Planning and Zoning Board

Staff Report

CASE NUMBER: ZON18-00149
LOCATION/ADDRESS: The 9800 through 9900 blocks of East Hampton Avenue (south side) and the 1400 Block of South Crismon Road (west side).
GENERAL VICINITY: Located at the northwest corner of US-60 and Crismon Road.
REQUEST: Rezone from PEP-PAD-CUP to PEP-PAD.
PURPOSE: This request will allow for an office and commercial development.
COUNCIL DISTRICT: District 6
OWNER: Crismon Superstition Partners
APPLICANT: Gilmore Planning and Landscape Architecture
STAFF PLANNER: Lisa Davis, AICP Planner II

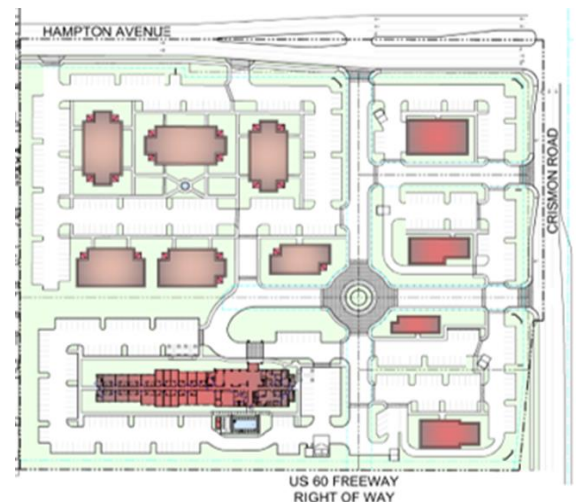
The PAD modifications and conceptual site plan indicate a building and landscape setback between the conceptual lots. These setbacks are inconsistent with the purpose of the PEP district to create an integrated campus setting and are not needed. Staff recommends eliminating the proposed interior side and rear yards between the conceptual lots (condition #8c).

The conceptual site plan does indicate that the proposed lots will not all have frontage on the public right of way. The MZO Section 11-30-6.H requires that every lot shall have frontage on a dedicated public street unless the lot is part of an approved PAD. As part of the PAD overlay the applicant is requesting lots that do not have frontage on the public right of way. Cross access and reciprocal parking easements will be required to be recorded as part of this development. Condition 7 outlines Staff supported PAD modifications.

- ii. **Removes interior and side yard setback standards that are not consistent with PEP requirements.**
 - b. **A revised conceptual site plan with the buildings moved closer to Hampton and no drives or parking between the buildings and the street and improved pedestrian connectivity between the various land uses.**

Pedestrian Areas (Z10-024 design guidelines page 11)

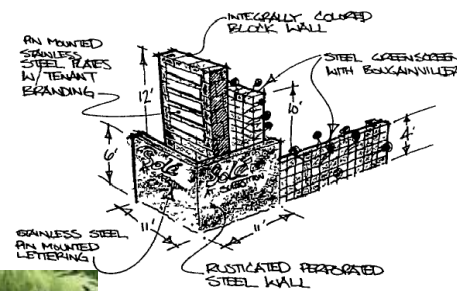
Detailed information will need to be provided at the time of Site Plan Review and Specific Plan for full review. Other concerns include the landscape strips announcing the main entrance to the site from Hampton Road may be too narrow to support adequate tree planting or growth. It is unclear if the proposed buildings meet the foundation base requirements. The current PAD Design Guidelines for Superstition at Sole, Z10-024 includes emphasis on pedestrian areas, page 11, and architectural design standards, page 14, with pedestrian environment in mind. These should be retained in the design guidelines for the current application (Condition #9a).

Where pedestrian pathways meet and cross vehicle pathways, decorative and / or textured pavements will be used. Barrier posts, bollards, screen walls, or large potted plants are to be used to provide safety to pedestrians from vehicular traffic.

- a. **The incorporation of the site development standards for pedestrian areas (page 11) and architectural design standards (page 14) in the approved Superstition at Sole Design Guidelines (Z10-024).**
